**Subject: Improvements for cyclist crossing - Centenary Bikeway, Dandenong Road**  
To Metropolitan Region Project Team

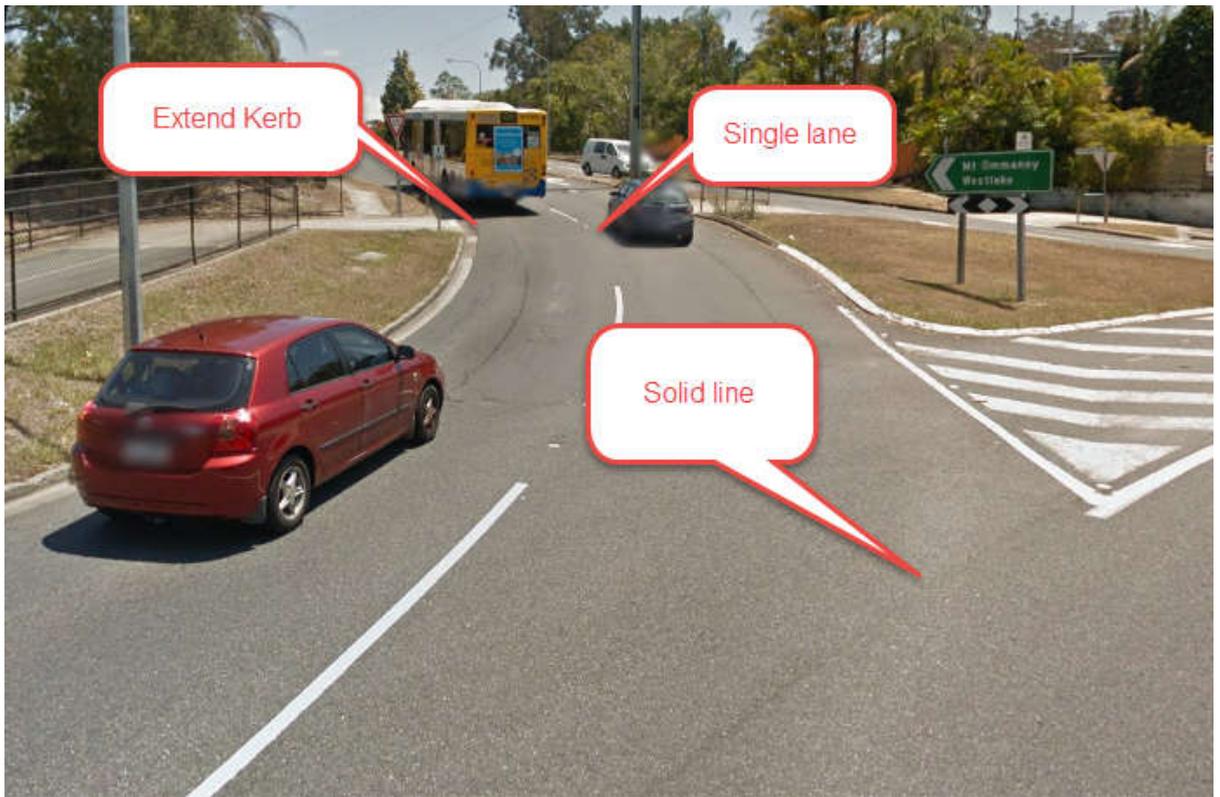
- a) Painting the cycle crossing “stop lines” and balance bars further back from the kerb
